**CORRESPONDENCE COVER SHEET
WASTE PERMITS DIVISION
TEXAS COMMISSION ON ENVIRONMENTAL QUALITY**

Facility Name: City of Victoria Landfill

Re: Response to Second Technical Notice of Deficiency (TCEQ Tracking No. 27435345)
City of Victoria Landfill (Type I)
Victoria, Victoria County, Texas
CN600243257/RN100212968
Proposed TCEQ Permit Number MSW-1522B
Major Amendment Permit Application

project	107608	contract	-
drawing	III.A1.4	rev.	2
sheet	5	of	25
file	107608III.A1.4.dwg	sheets

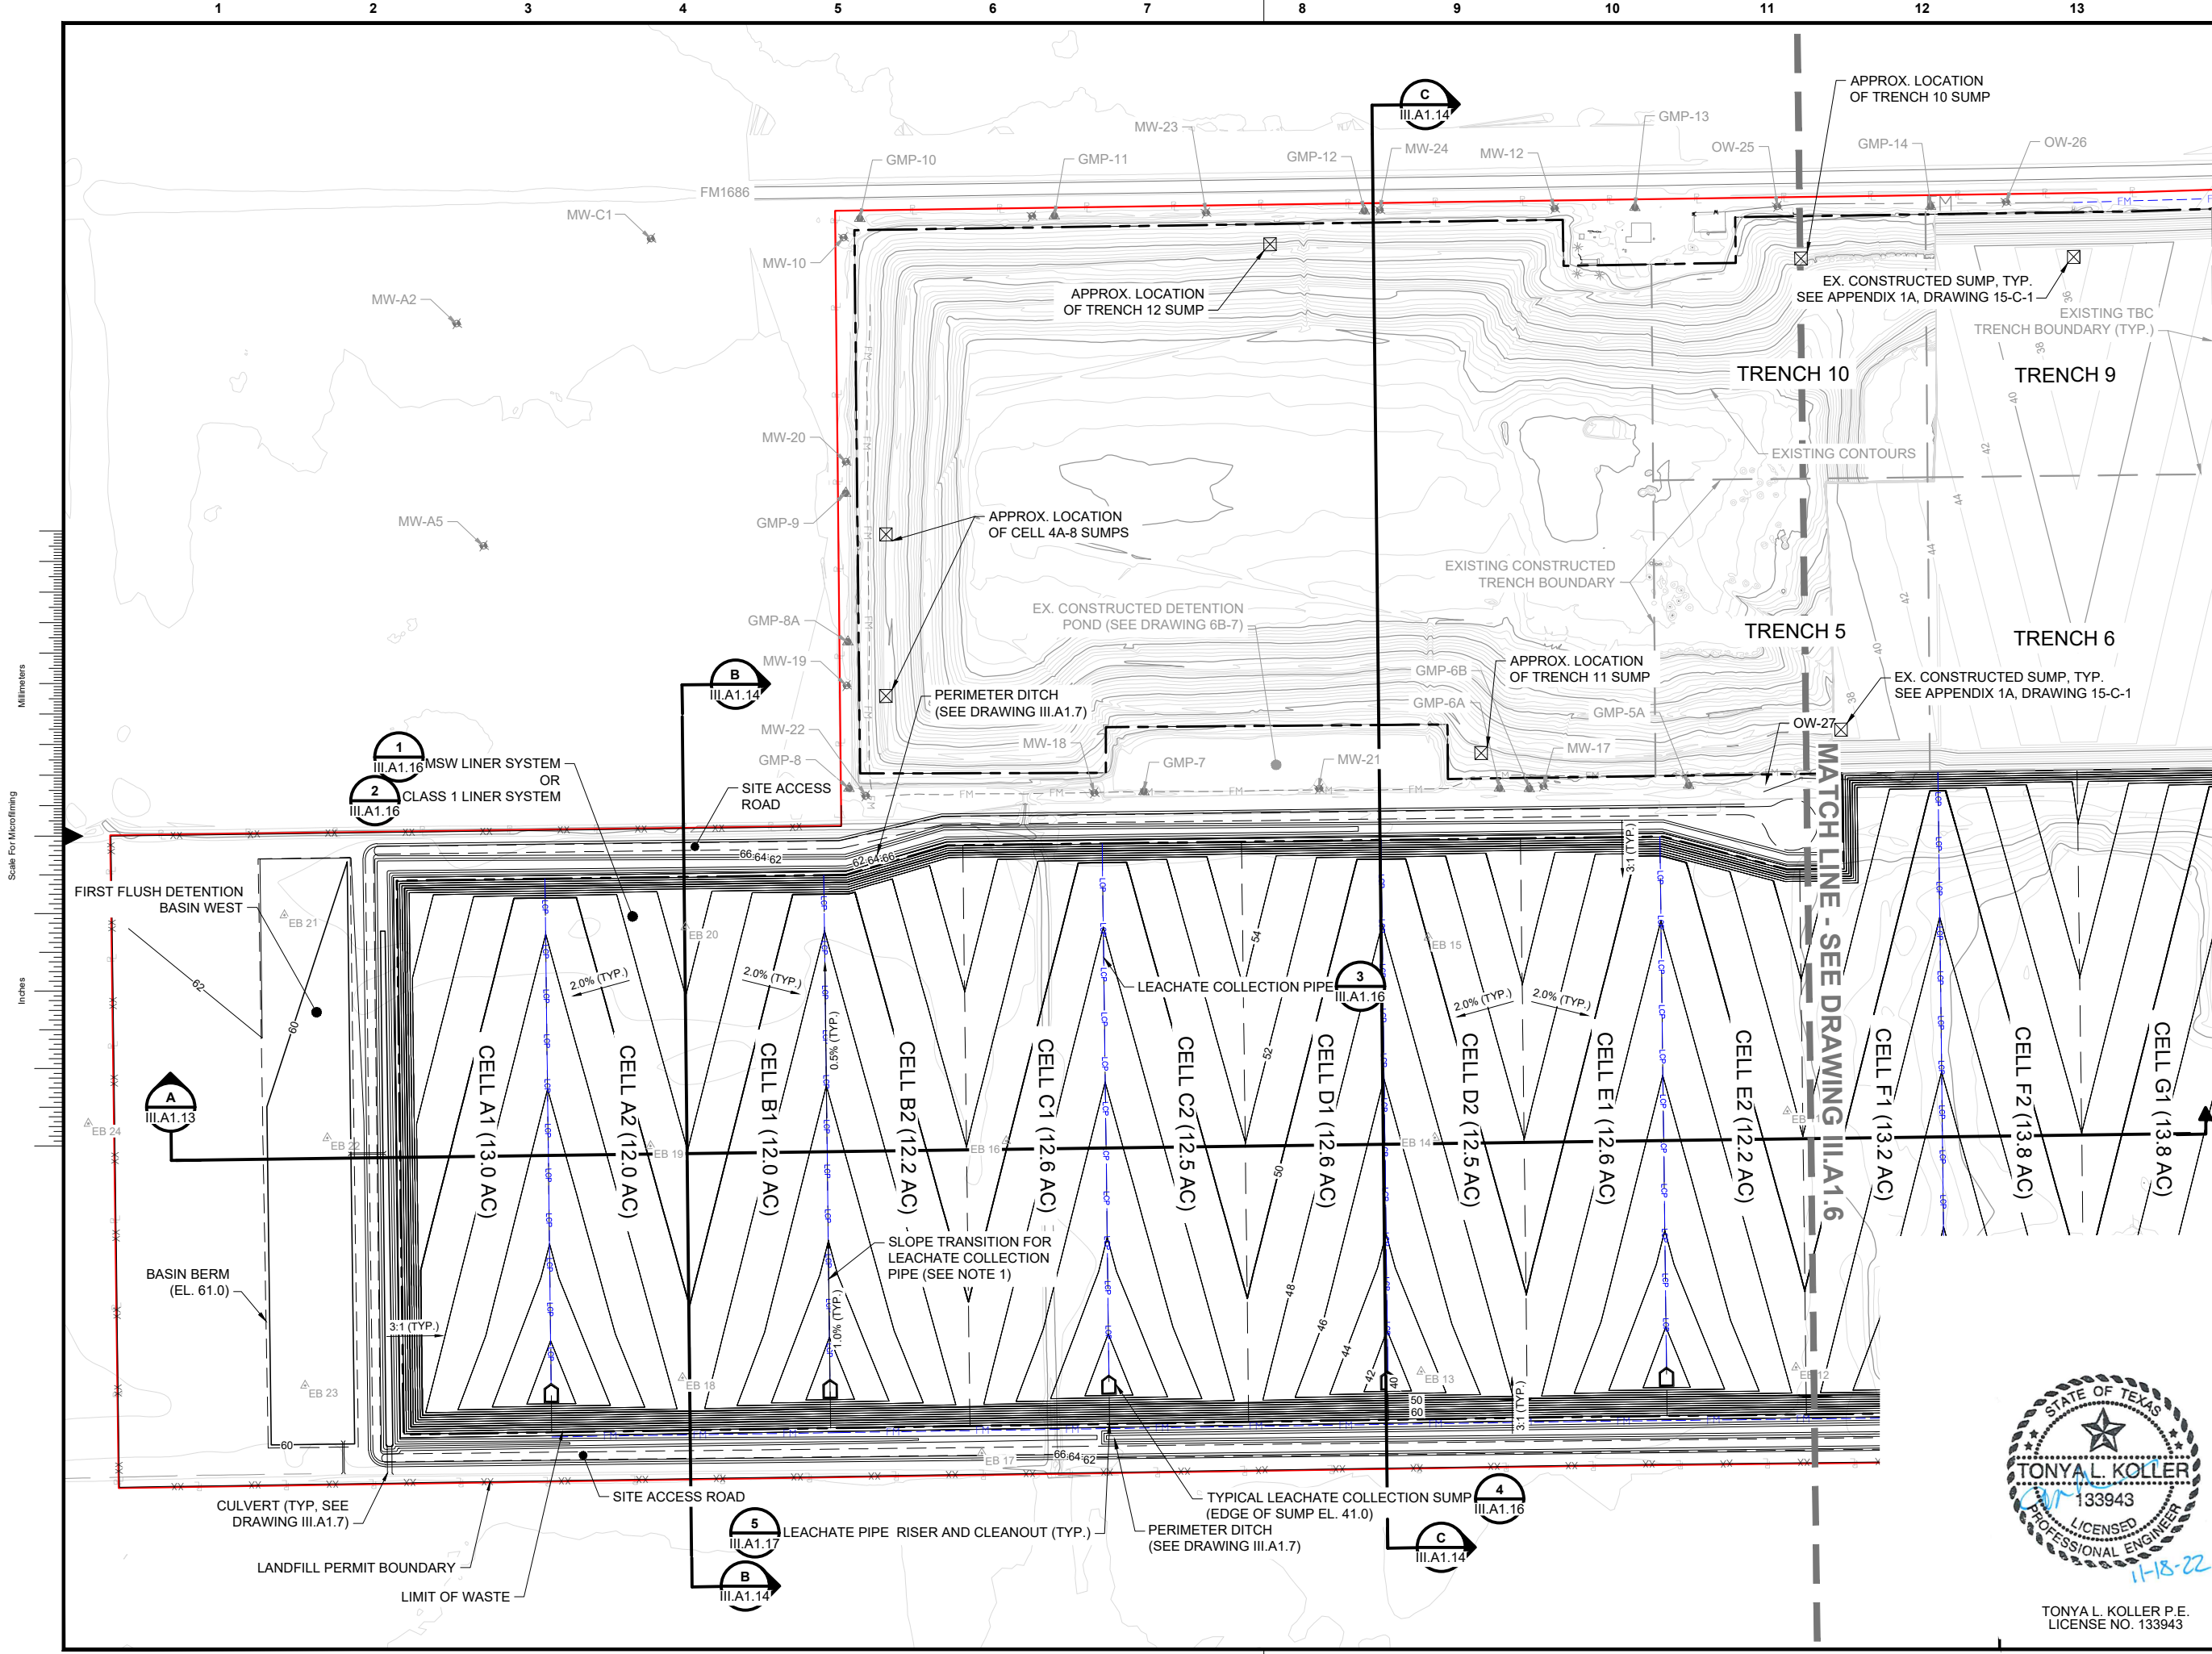
<i>h. Regarding areas where vertical expansions are proposed over the existing areas, revise to discuss leachate sump design and operation. Revise Drawing III.A1.4 and other relevant drawings to show sumps for the western portion of the existing/authorized areas.</i>	Section 2.3.2 of Part I/II has been revised to address leachate sumps in the vertical expansion area. As described in Attachment III-3-Leachate and Contaminated Water Plan, the previously permitted leachate sumps, conveyance, and storage design for this area are expected to be sufficient as increases in waste column will reduce peak leachate production and the prescriptive final cover design will reduce infiltration. Any sumps in Trench 5-10 have been added to Attachment III-1, Drawings III.A1.4-6 as appropriate.
T4	<i>a. As requested in the previous comment, revise Section 14.9.1 of Part I/II and other relevant portions of the application (for example, but not limited to, Section 4.6.1 of Part III) to use porosities determined from testing the actual materials involved. The effective porosities used in</i>	Section 14.9.1 of Part I/II and Section 4.6.1 of Part III have been revised to clarify assumptions and the associated justification for the selected porosities.

project	contract
107608	-
drawing	rev.
III.A1.17 - 2	
sheet 19 of 25	sheets
file 107608III.A1.17.dwg

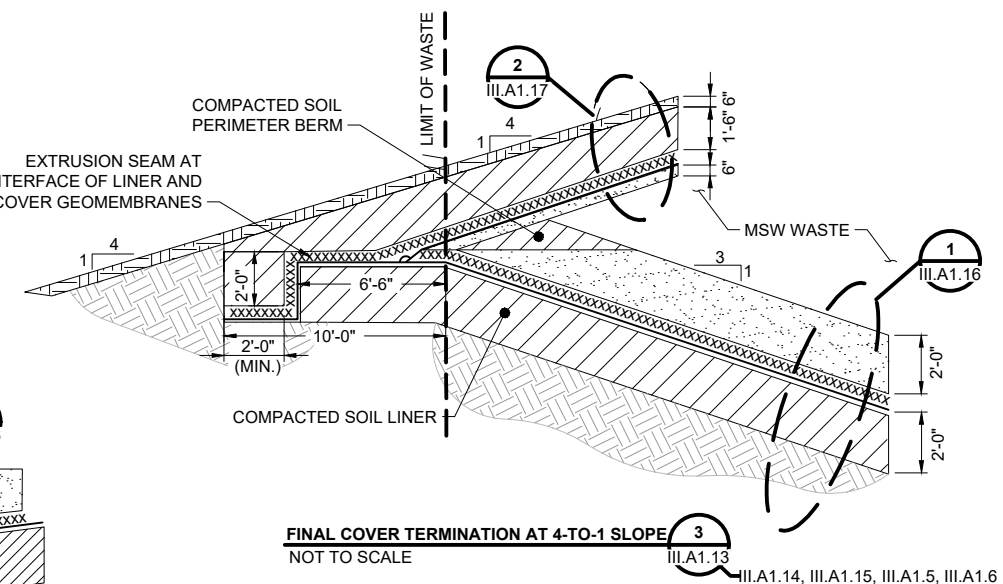
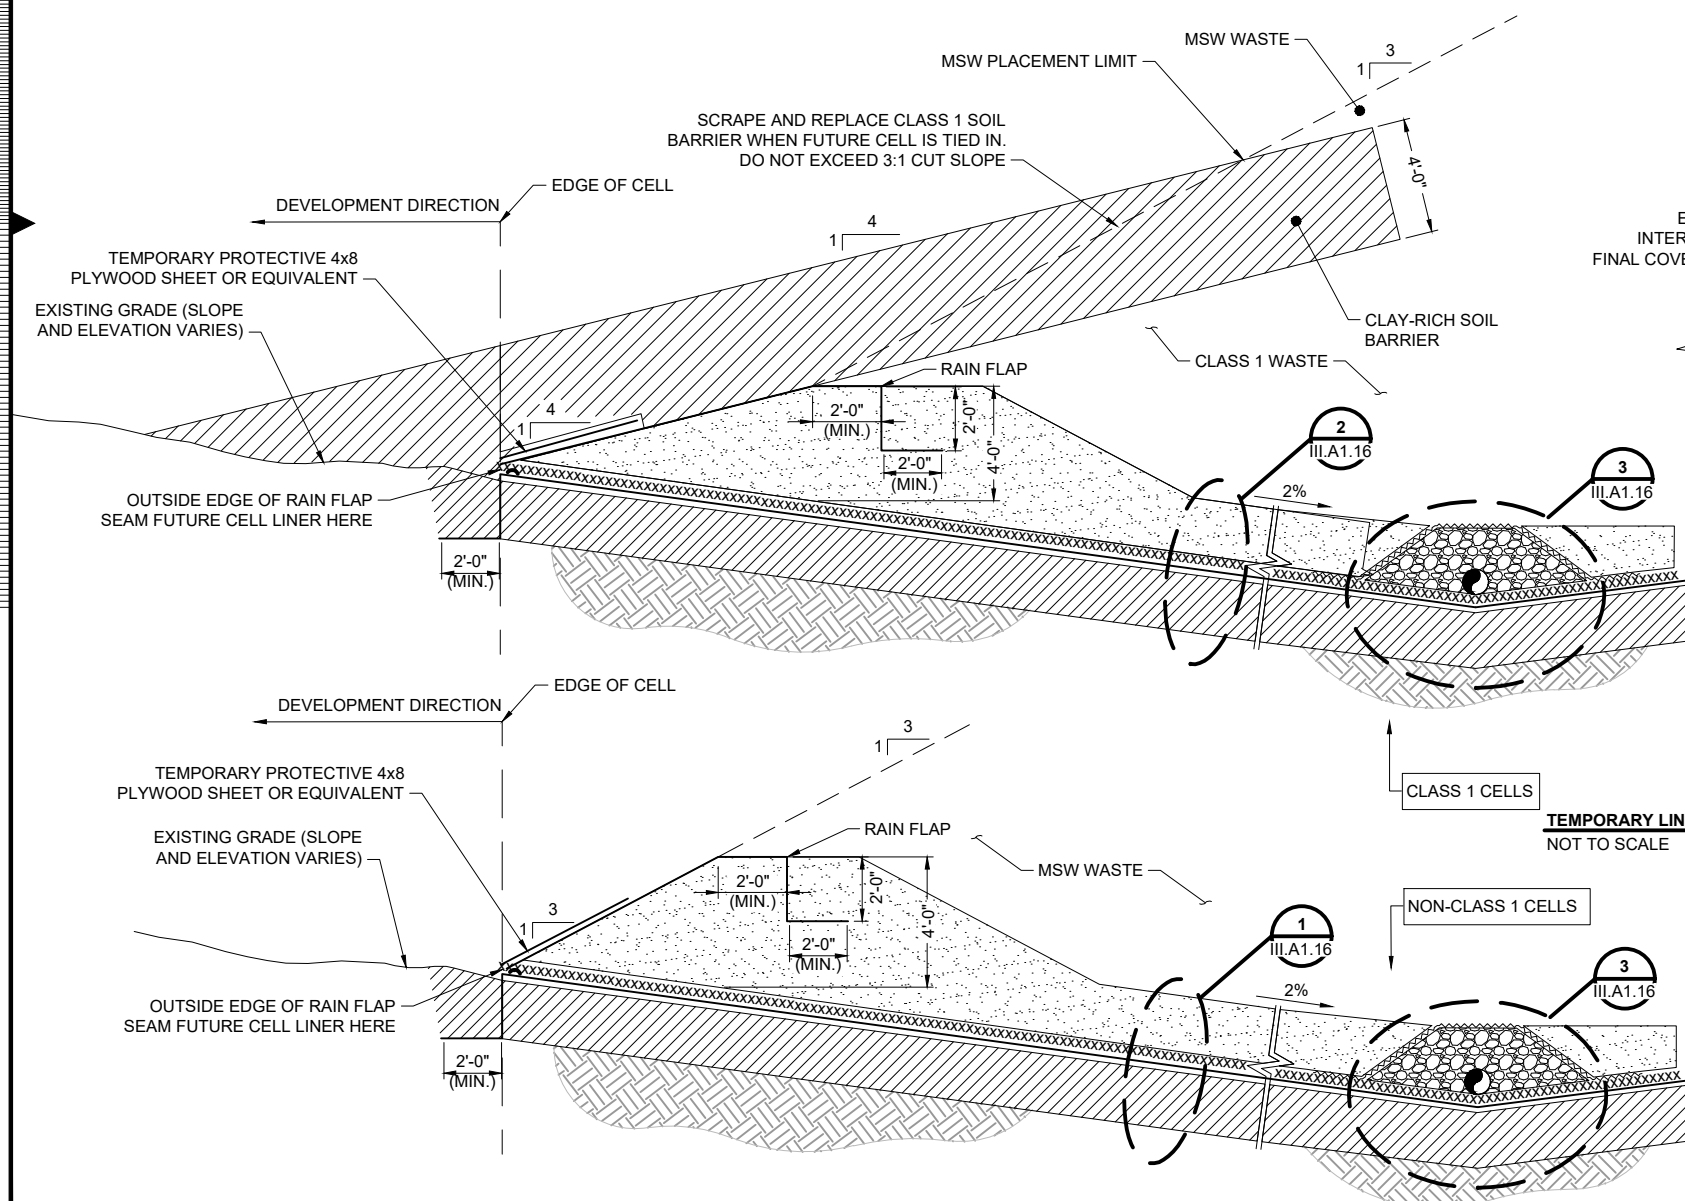
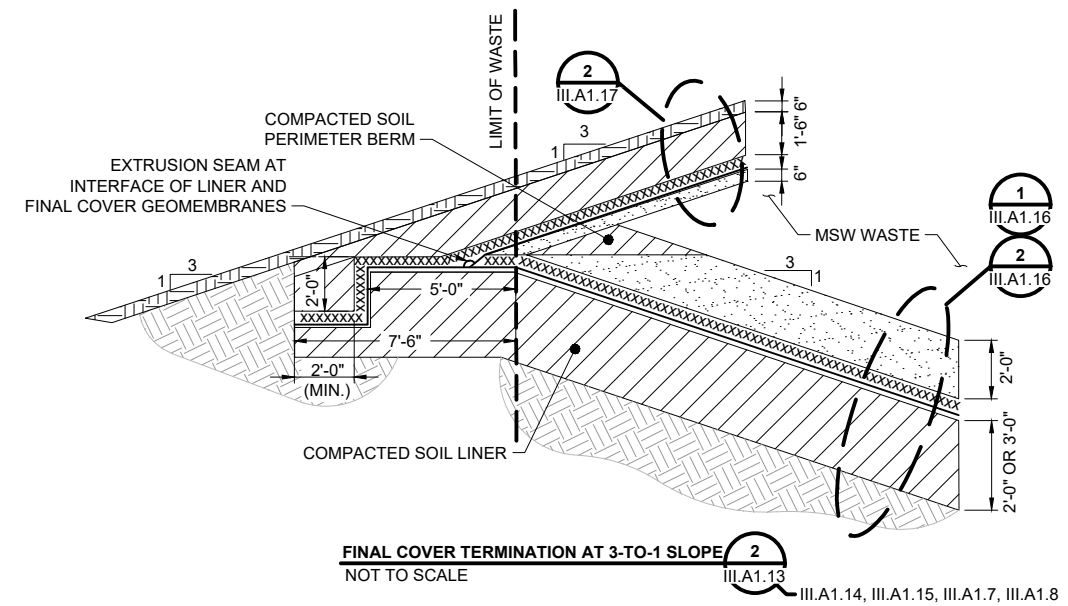
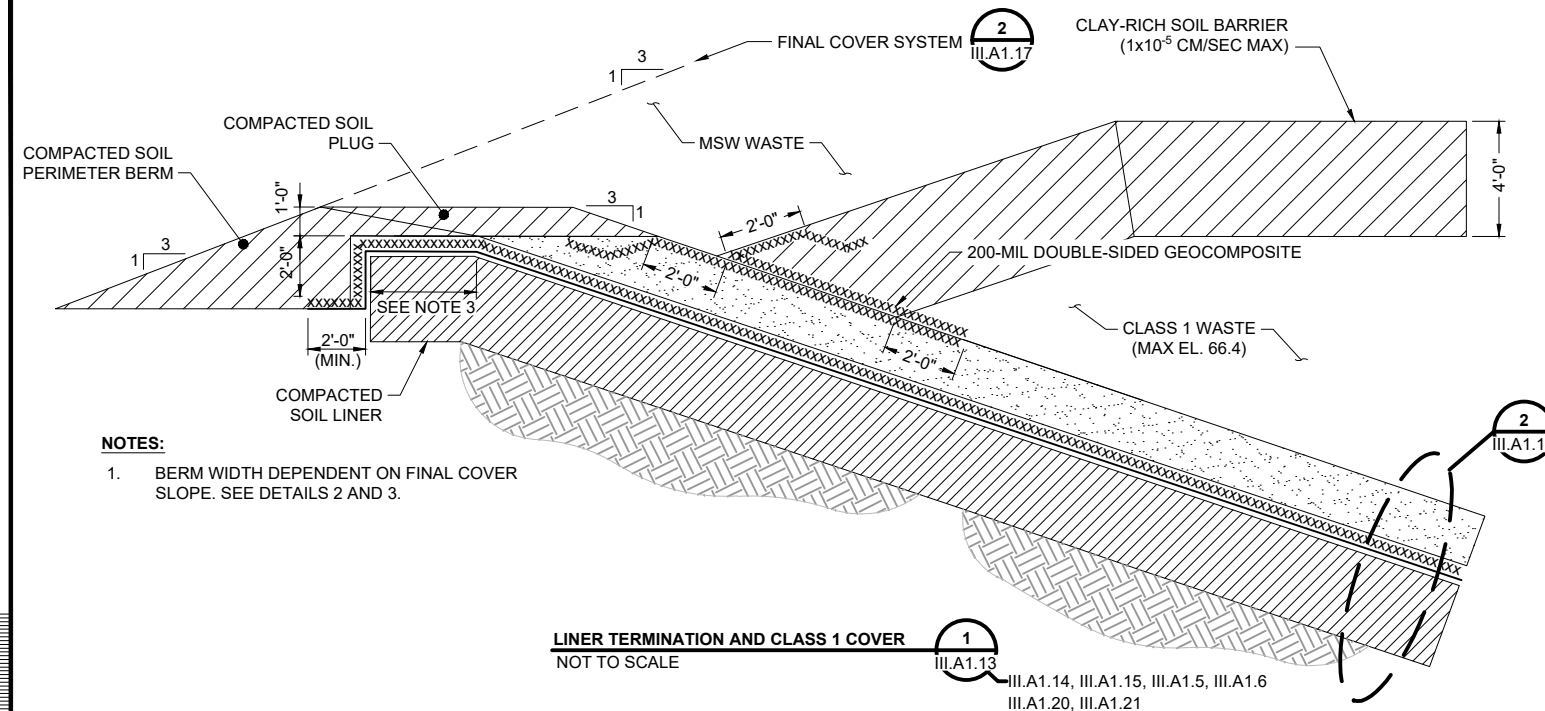
<i>c. Detail 6 added to Drawing III.A1.17 seems to show berms built on intermediate cover. Note that under 330.165(a) and (c), runoff from intact daily cover or intermediate cover is not considered as having come into contact with the working face or leachate. Revise Detail 6 and other relevant portions of the application as appropriate. Also, refer to the above comments.</i>	Detail 6 on Drawing III.A1.17 in Attachment III-1 has been revised to remove the intermediate cover that had been shown within the active face while keeping the 2-foot depth of the containment/diversion berms. The term "Stormwater" has been changed to "Uncontaminated Water" per comment T8(a).
	<i>d. The responses to Comment T31 of the first NOD stated that evaporation pond has been removed from the application. The revised application still includes evaporation pond as a leachate management</i>	Evaporation has been removed from the application, including from Sections 2.2.6 and 2.2.7 of Attachment III-3.
